WEST VIRGINIA RIVERS

March 17, 2017

RE: MVP 401 Application (WQC-16-0005)

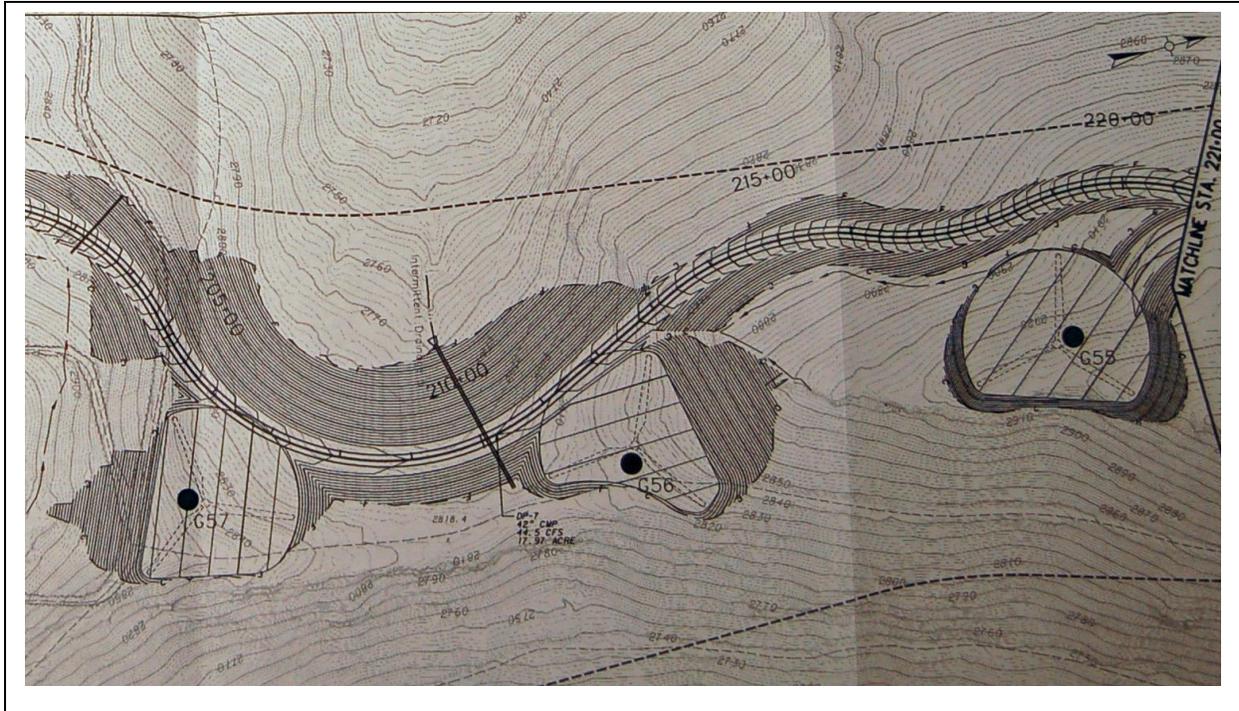
The construction plan sheets submitted by MVP in the Site Registration Application provide contours of the existing land surface and indicate the locations of the proposed pipeline work corridor, access roads, work spaces, and erosion and sediment controls. However, there are no drainage area delineations, no drainage direction arrows, and no contours depicting the leveled work corridor and work areas or cut and fill. Figure 2.0.1 is an example of a construction plan sheet submitted to WVDEP for a stormwater management permit. The contours of the existing ground surface are provided, along with the contours associated with the roadway and work pad construction areas. Additionally, drainage areas are delineated and drainage arrows are provided. Figure 2.0.2 is an example of a drainage area delineation. The MVP construction plans are deficient because they do not provide the contours depicting changes resulting from construction and do not provide delineations of drainage areas or drainage direction arrows.

Figure 2.0.2 – Example of drainage area delineation from the ridge line to the low point on the project, excerpted from the Erosion and Sediment Control Best Management practice Manual, WVDEP, 2006, Rev. 2016.

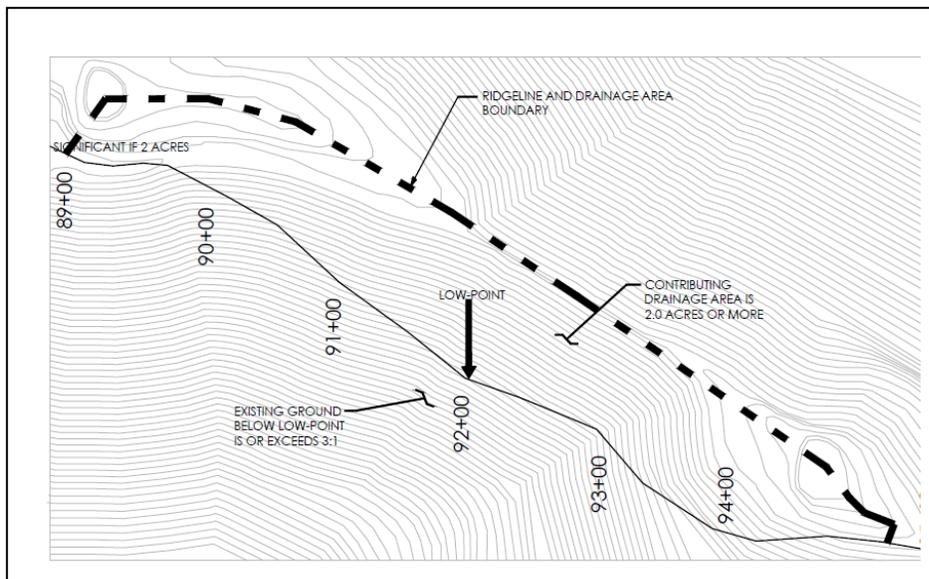
Drainage Area Delineations Provide Information Necessary for Calculating Discharge Velocities and for Sizing Erosion and Sediment Controls

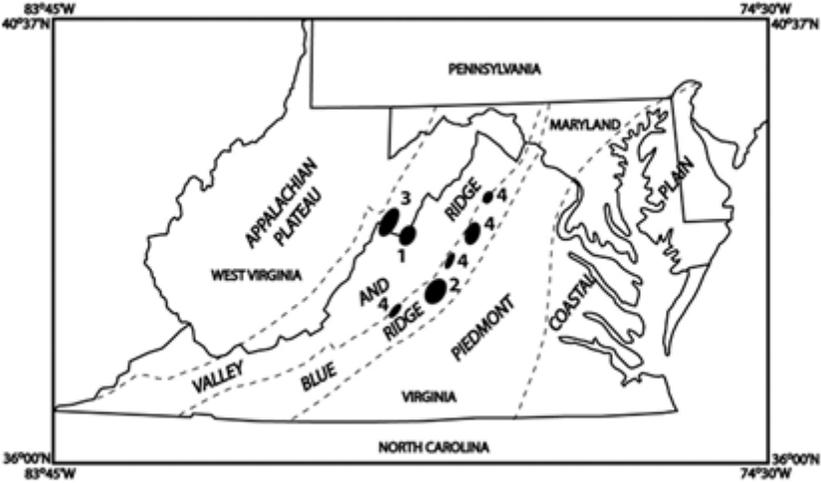
6	6-23	6.4.1.5	<p>Describe historic accounts of landslides from the May 31, 1897 earthquake. It is important to find out as much as possible about these landslides because these types of landslides will likely be common with earthquakes of similar or greater magnitude.</p> <p>In addition, consider potential for landslides generated by earthquakes with epicenters outside the GCSZ or PFZ, such as described by Jibson and Harp, 2012.</p> <p>Jibson, R.W and Edwin L. Harp, E.L., 2012, Extraordinary Distance Limits of Landslides Triggered by the 2011 Mineral, Virginia, Earthquake, Bulletin of the Seismological Society of America, Vol. 102, No. 6, pp. –, December 2012, doi: 10.1785/0120120055</p>
6	6-23	6.4.1.5	<p>Identify the large rock block landslides on Sinking Creek Mountain. The pipeline corridor traverses the JNF on the southeast flank of Sinking Creek Mountain. A series of large rock block slides extends for miles along the southeast flank of Sinking Creek Mountain (Schultz, A.P., 1993). Schultz (1993) states that the analysis shows that the rock block slides may have been emplaced as a single catastrophic event of short duration. Schultz and Southworth (1989) state: “The apparent clustering of large landslides near the Giles County, Virginia seismic zone suggests that seismic shaking may have been an important triggering mechanism.”</p> <p>Whisonant, Watts, and Kastning (1991) did a study of landslides in the Giles County Seismic Zone (GCSZ) and identified landslides on Sinking Creek Mountain and elsewhere as landslides likely to be of seismic origin or to contain evidence of seismic events.</p> <p>Review and discuss the studies which have considered earthquakes as a triggering mechanism for the large rock block landslides on Sinking Creek Mountain, such as:</p>

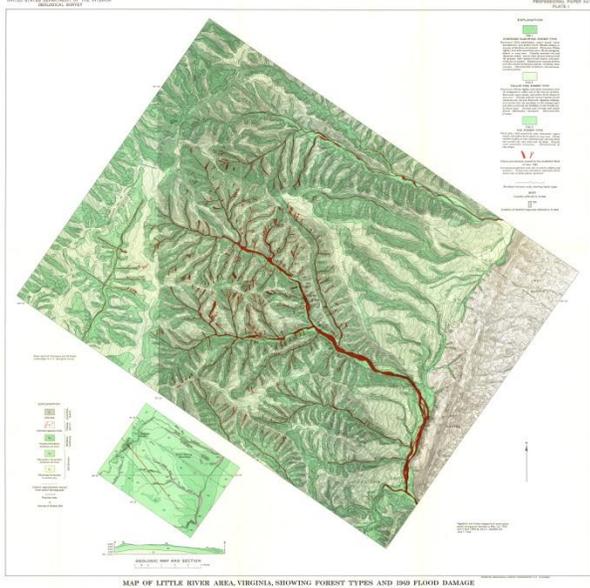
6	6-34	6.4.3	The Landslide section states: "Areas where the alignment crosses steep hill slopes are identified in Table 6.4-6, and Appendix 6-D.3 includes a map set depicting these areas. As shown in the table, the pipeline route traverses approximately 3.8 miles of steep hill slopes that of potential stability or landslide concern." The steep slopes on the JNF are not identified in Table 6.4-6, and Appendix 6-D.3. Identify the steep slopes on the JNF by milepost and slope (%).
6	6-36	6.4.3	The Slope (%) column in Table 6.4-6 has a footnote: "a/ Design slope is based on desktop and field review, or range from map analysis of alignment." Specify how the Slope (%) was calculated for the JNF portion of the pipeline corridor. Was Slope (%) calculated using 10 meter DEM or other basis. Define what Slope (%) is considered "steep" for Table 6.4-6, and Appendix 6-D.3.
6	6-37	6.4.3	The Landslide section of Resource Report 6 failed to recognize the largest known landslides in eastern North America on Sinking Creek Mountain. The pipeline corridor on the JNF crosses Sinking Creek Mountain which has the largest known landslides in eastern North America (Schultz and Southworth, 1989). The pipeline corridor on Sinking Creek Mountain (MP 217.2 – 218.0) traverses one of the large bedrock landslides mapped by Schultz (1993). The Landslide section of Resource Report 6 failed to identify this large bedrock landslide on a published geologic map (Schultz, 1993).

RR# Or Plan Name	Page #	Section #	Comment
			The failure of the Landslide section of Resource Report 6 to recognize an existing large bedrock landslide traversed by the pipeline corridor and the failure to assess the potential for large bedrock landslides in the pipeline traverse of Sinking Creek Mountain needs to be corrected by an investigation conducted by an engineering geologist.
6	6-37	6.4.3	The pipeline corridor on the JNF crosses Peters Mountain which has some similarities (lithologies, structures, etc.) to Sinking Creek Mountain. The failure of Resource Report 6 to recognize and assess potential for large bedrock landslides (similar to the Sinking Creek Mountain landslides) in the pipeline traversing of Peters Mountain needs to be corrected by an investigation conducted by an engineering geologist.
6	6-37	6.4.3	The pipeline corridor on the JNF crosses Peters Mountain, Sinking Creek Mountain, and Brush Mountain. These mountains have the potential for more frequent types of rockslides of lesser dimensions than the large bedrock landslides of Sinking Creek Mountain. The failure of Resource Report 6 to recognize and assess potential more ordinary types of rockslides in the pipeline traverse of Peters Mountain, Sinking Creek Mountain, and Brush Mountain needs to be corrected by an investigation conducted by an engineering geologist.
